**WARREN LAKE DAM
VT 00263**

**PHASE I INSPECTION REPORT
NATIONAL DAM INSPECTION PROGRAM**

**DEPARTMENT OF THE ARMY
NEW ENGLAND DIVISION, CORPS OF ENGINEERS
WALTHAM, MASS. 02254**

JULY 1981

GENERAL PLAN

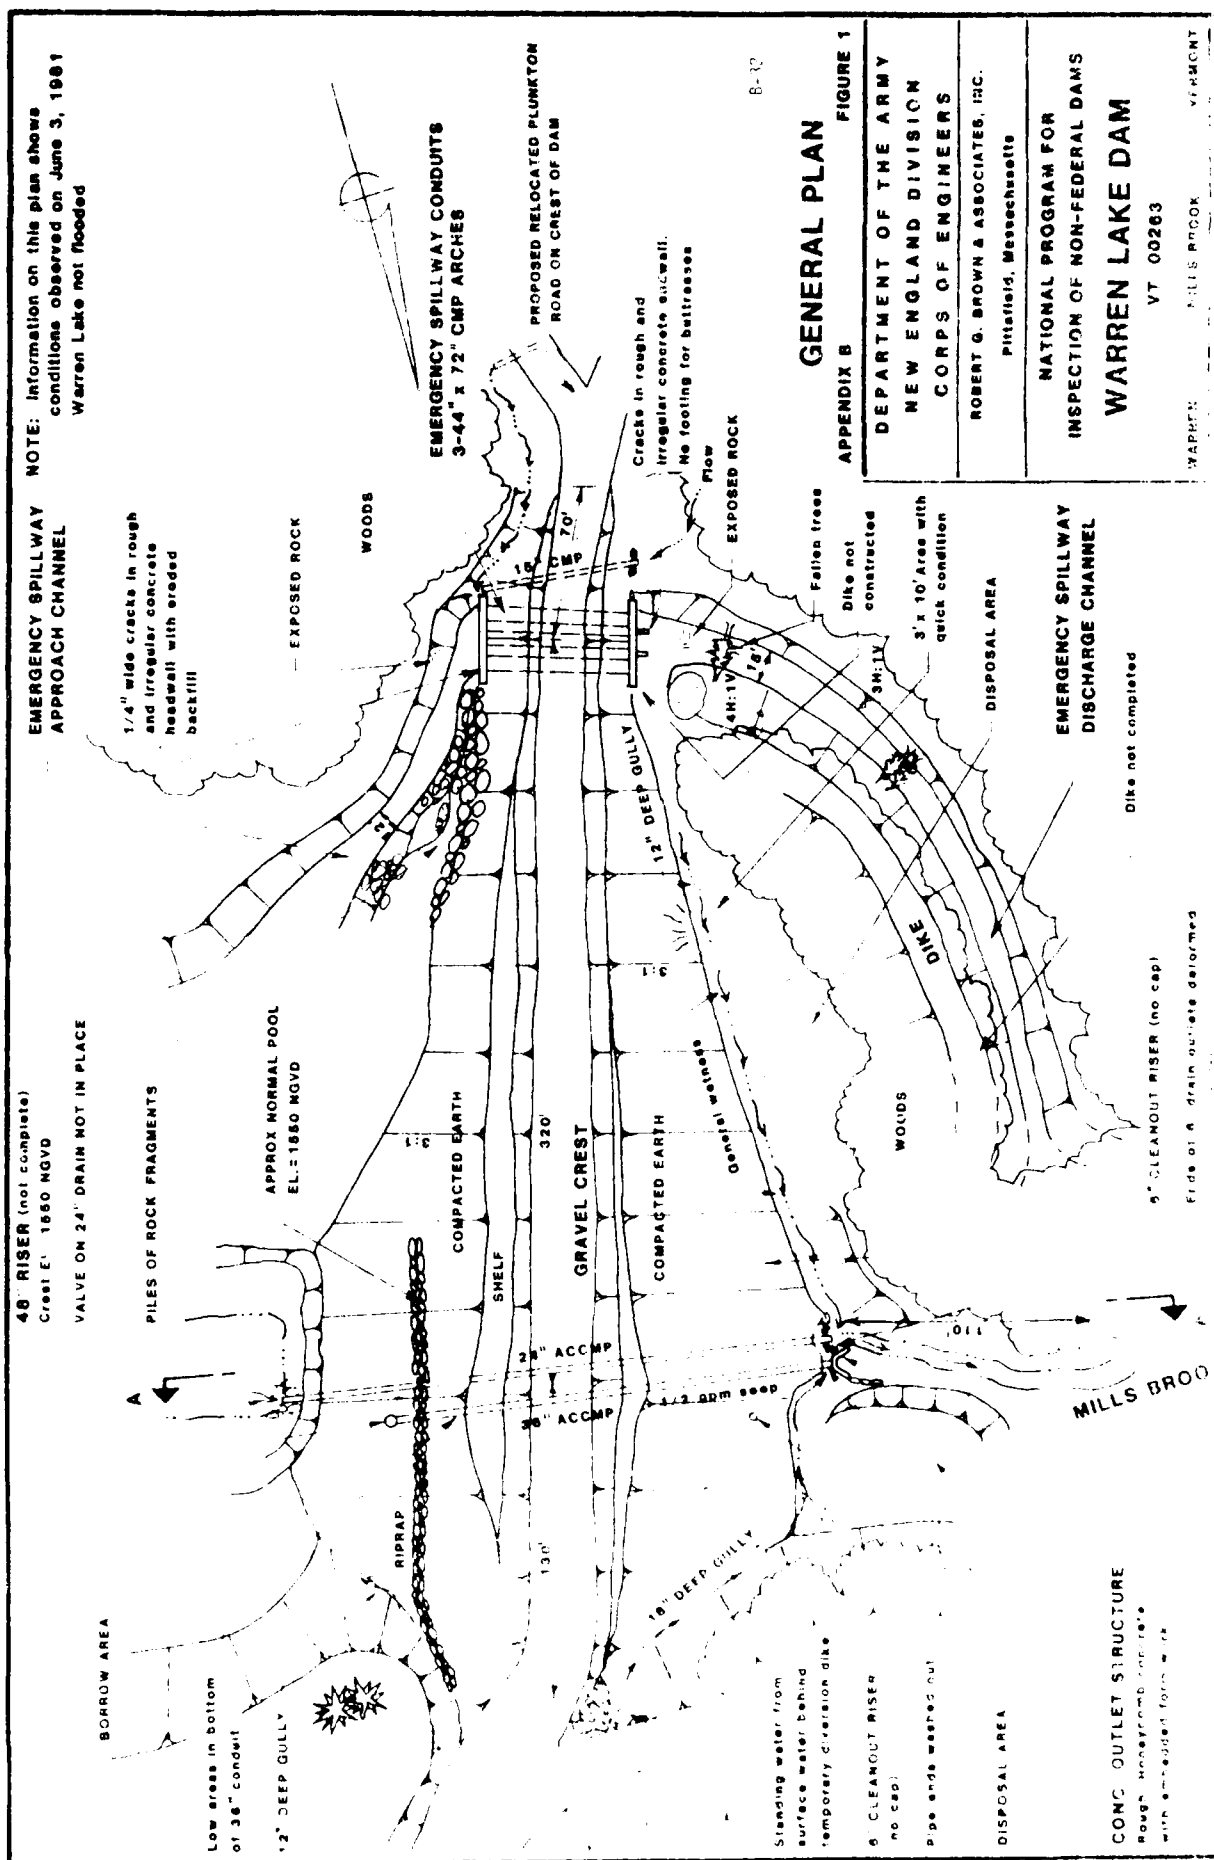
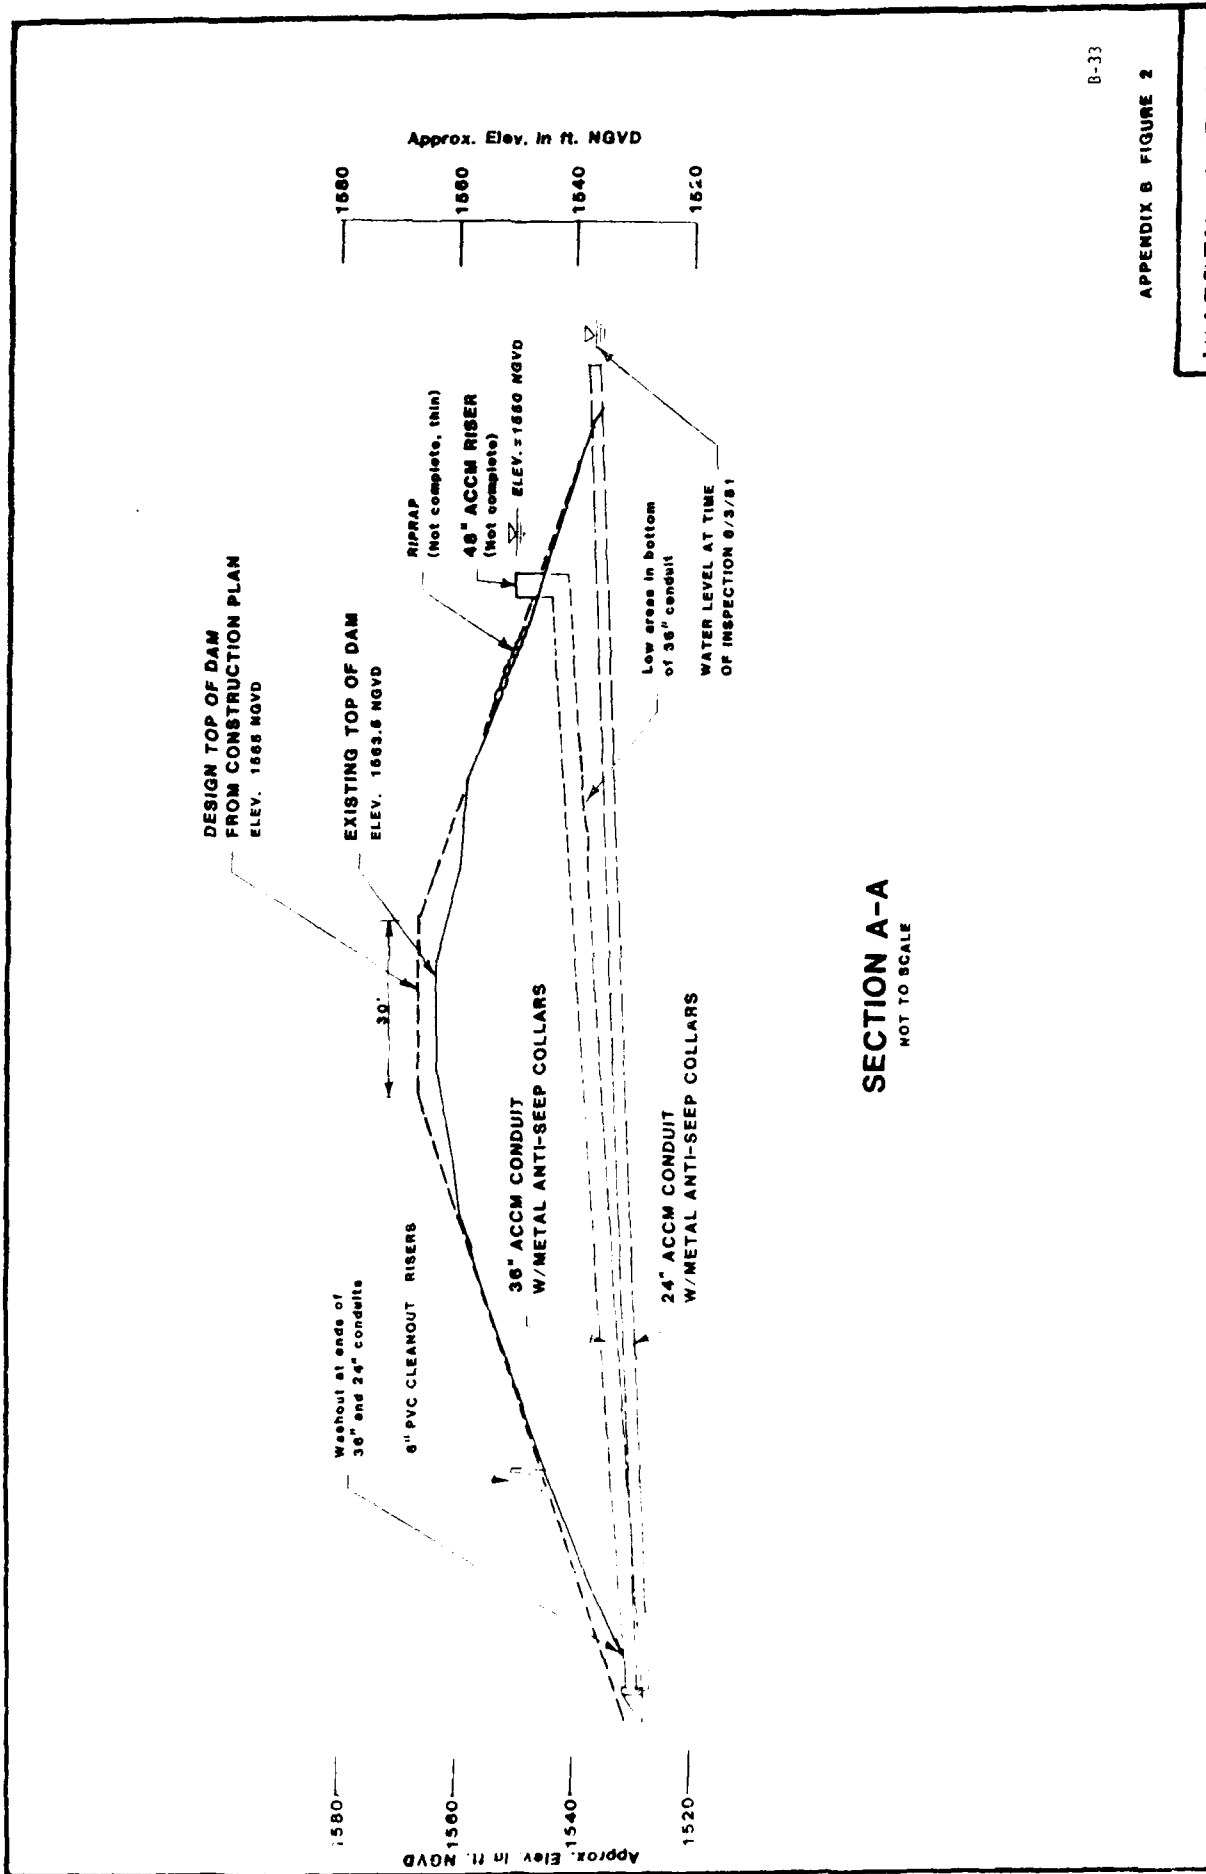
The shapes and layout of both the approach channel and discharge channel for the emergency spillway vary from the design plan (see Appendix C, Photographs 10 and 13). Rock mass is visible in the sides of both channels.

The existing emergency spillway approach channel has a width of about 12 feet at a point 80 feet upstream of the inlets to the emergency spillway culverts. The design plan calls for a width of 60 feet at this point. Rock is exposed in the sides of the approach channel. The owner reports that this rock cannot be excavated without blasting.

Trees are growing adjacent to the emergency spillway discharge channel. Several trees have fallen across the channel. An earth dike along the north side of the discharge channel has not been constructed as of this inspection. This dike is necessary to prevent emergency spillway flow from being directed towards toe of the dam. The existing emergency spillway discharge channel has a bottom width of about 12 feet and 3H to 1V side slopes except that the channel has steeper side slopes where it is in rock cut. The discharge channel called for on the design plans varies in width from 35 feet at the dam to 85 feet at a point 400 feet downstream of the dam.

- Investigate the hydraulic adequacy of the emergency spillway approach and discharge channels and design repairs.
- Investigate the structural stability and design repairs to the concrete work for the emergency spillway culverts.
